820170100 Guardian Building

We have reviewed site plan file:

“07-SITE-820170100-C2.01.pdf V5” uploaded on/ dated **“8/15/2017”** and

Re: Guardian Building
Site Plan No. 820170100

C2.01

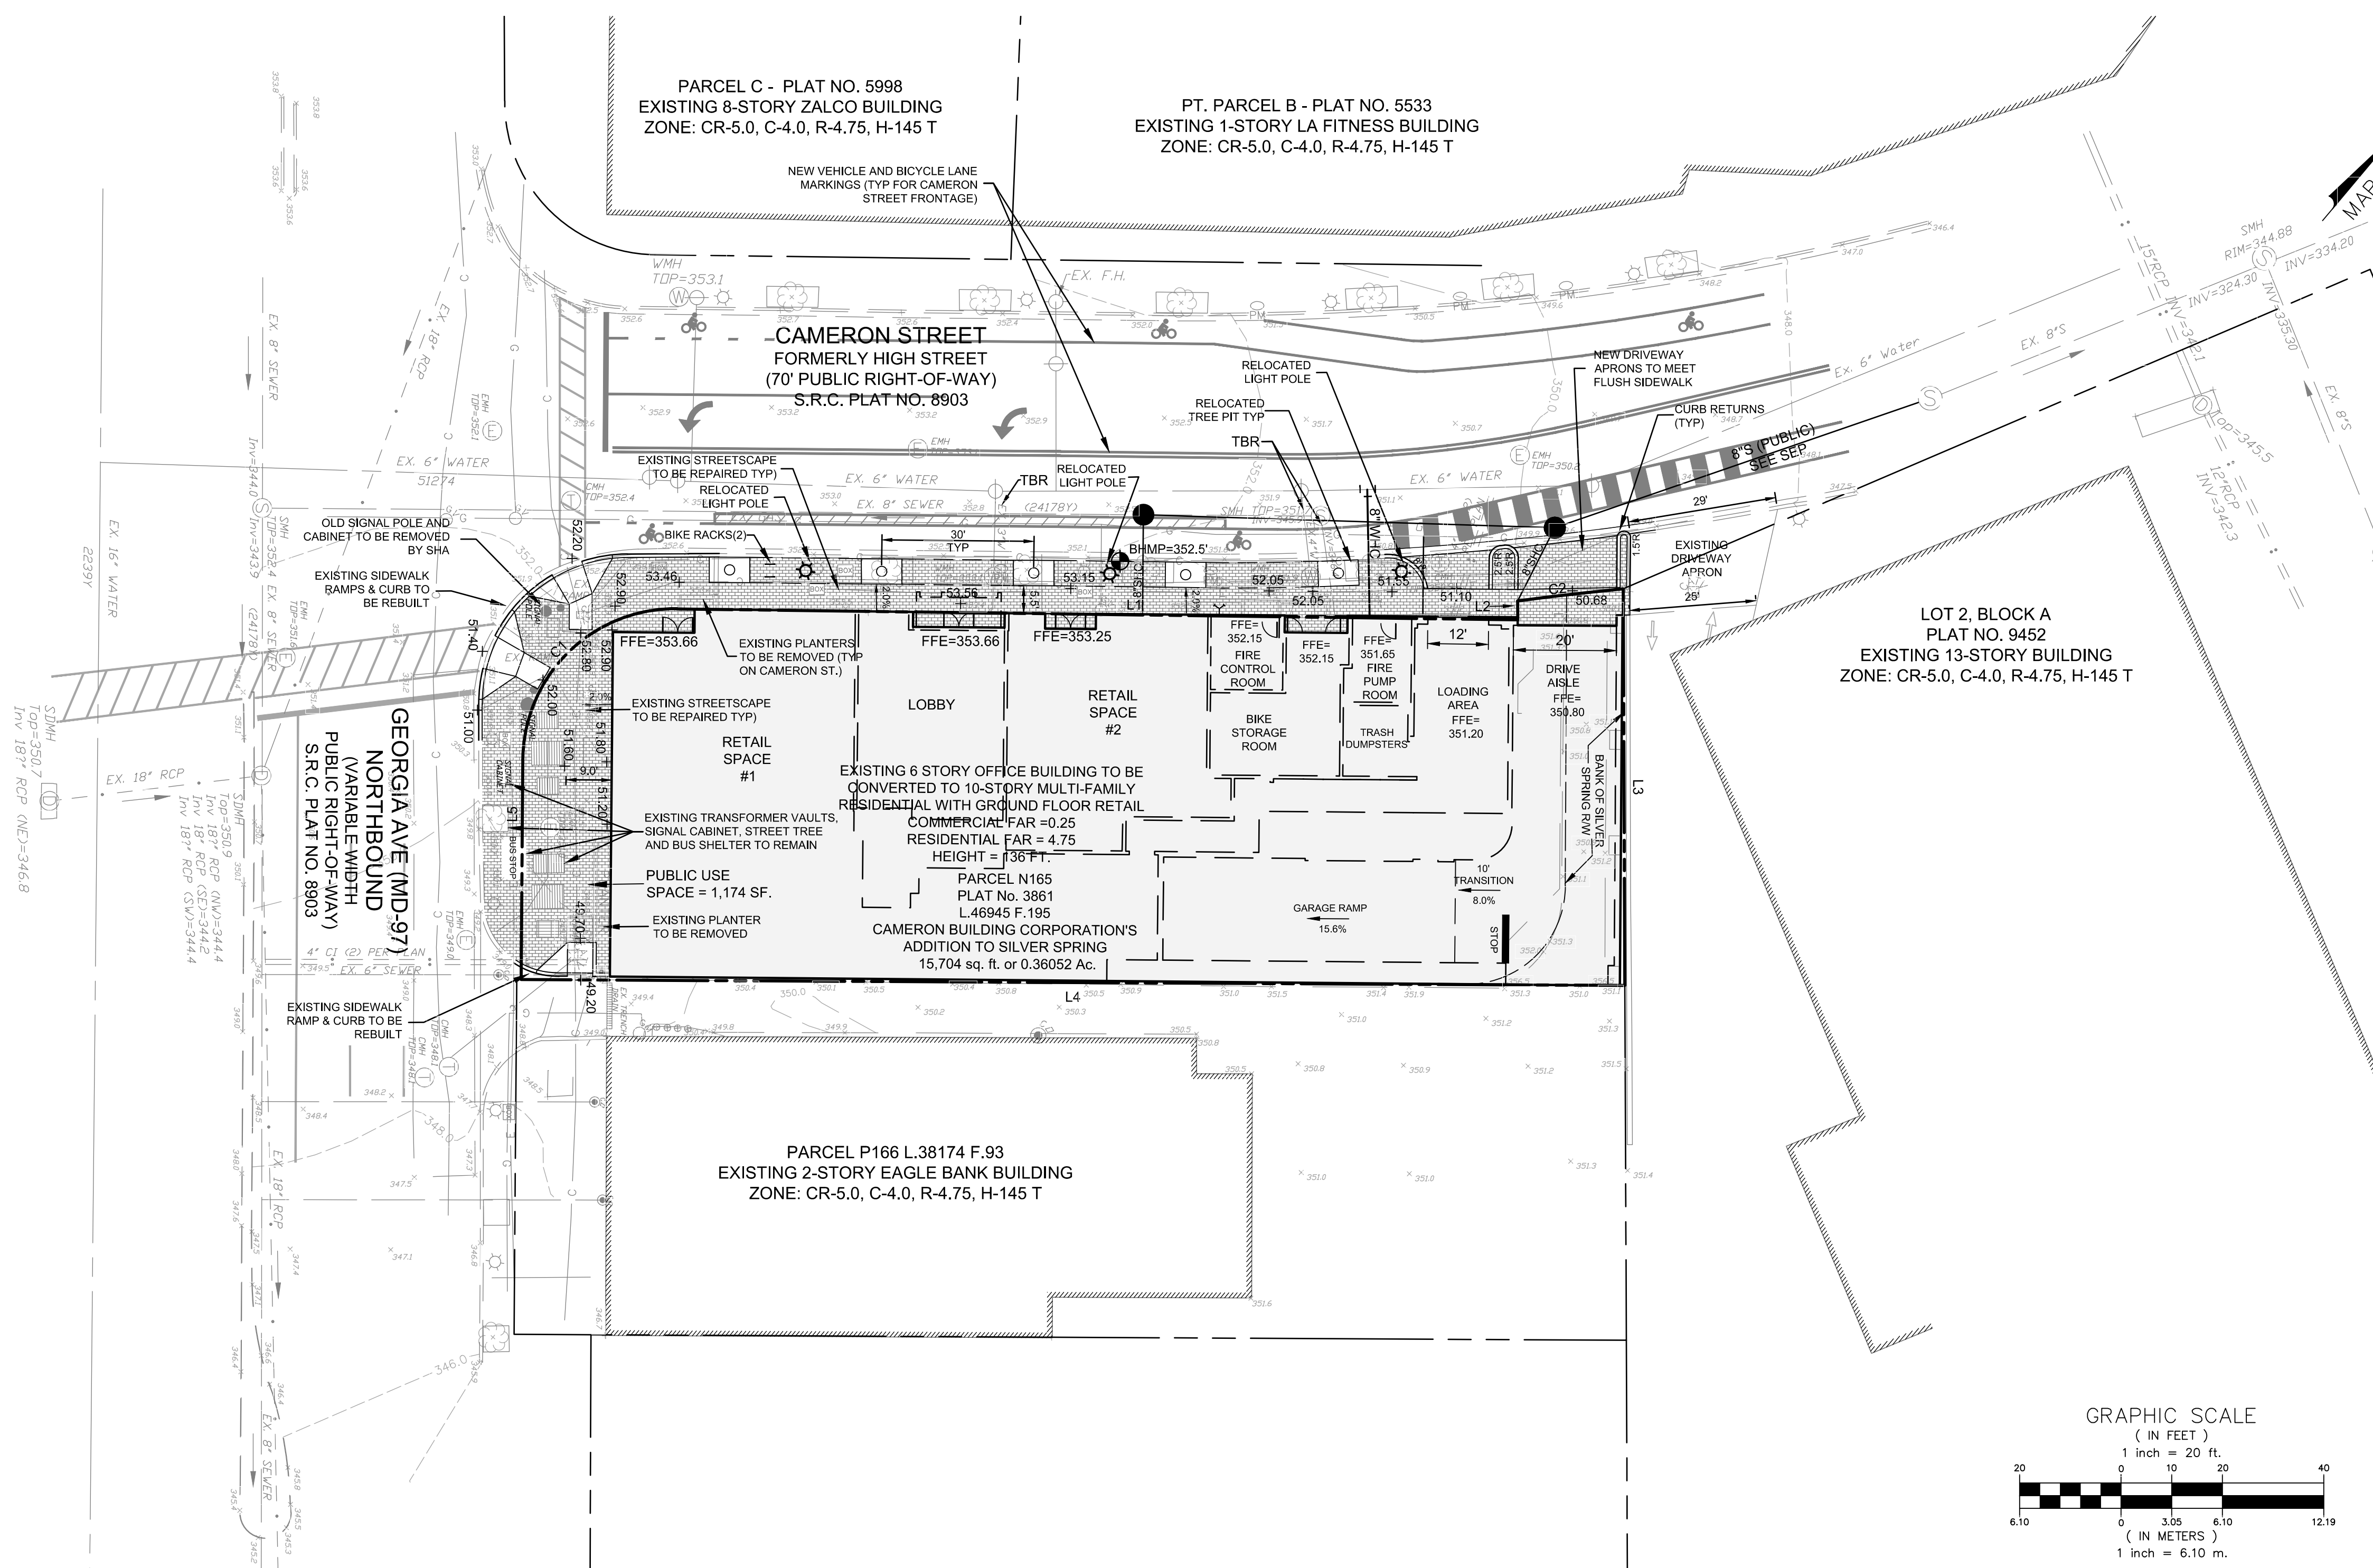
1. Clarify the pavement markings and the proposed road section on the plan by referring to the associated CIP project name and number.
2. Sight Distances Evaluation certification form needs to provide clear sight distance for all existing and proposed site entrances onto County-maintained roads or implement ways on the site plan to achieve that.

3. Public sidewalks:
 - a. Modify note 1 under “Site Plan Notes” to read: “Five (5) feet minimum of public (within ROW or PIE) ADA Compliant...”.
 - b. Public and private sidewalks when adjacent each other need to have the physical limits of maintenance provided or PIE/ ROW for the additional sidewalk is needed.

4. Coordinate parking meter relocations with MCDOT-Parking.
5. A Bus Rapid Transit (BRT) is proposed along Georgia Avenue and a BRT station is proposed on Georgia Avenue (MD 97) at Cameron Street per the approved 2013 Countywide Transit Corridors Functional Master Plan. We recommend that the applicant coordinate with Ms. Joanna Conklin, of Montgomery County DOT regarding the Bus Rapid Transit (BRT) on Georgia Avenue (MD-97). Ms. Conklin can be reached at joanna.conklin@montgomerycountymd.gov or at 240-777-7195.

The Silver Spring bikeshare service area is one of the most widely used in the County, and will likely be heavily used by the Project’s residents, on-site employees and visitors. Show a proposed location at the Project for a bikeshare station, as close as possible to the corner of Georgia Avenue and Cameron Street near the future BRT stop. Applicant should make every attempt to identify a potential location at the Project for a bikeshare station that is highly visible, convenient and well-lit, is 53’ x 12’ in dimension (to accommodate a 19-dock station), and receives at least 4 hours of sunlight per day. Applicant should plan to provide conduit in the event solar access is insufficient. Should an appropriate location not be feasible due to insufficient sidewalk widths or some other significant site constraint, Applicant and MCDOT will work together to identify an off-site location within the downtown Silver Spring bikeshare service area. Applicant will be required to pay the capital cost of bikeshare facilities and five (5) years of operating expenses. Applicant must take other actions in concert with the TMD to promote use of bike sharing among residents, employees and visitors at the Project, in order to accomplish the objectives of the TMD.
